750 W Streetsboro St

Conditional Use and Site Plan request for an artificial turf athletic field and restroom building.

Hudson Planning Commission	CONDITIONAL USE/SITE PLAN REVIEW – CHRIST COMMUNITY CHAPEL
Case No. 2025-231	June 9, 2025

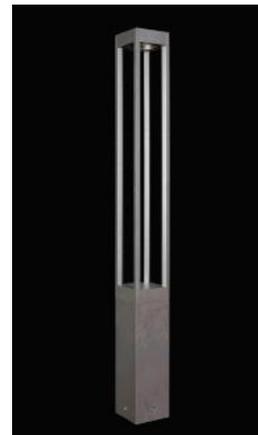
Staff Comment: 3 ½ ft pedestrian scaled bollards would illuminate the proposed perimeter walking path. The applicant has submitted the following figure to better depict the scale. The lighting would be programmed to shut off at 10:00 pm.
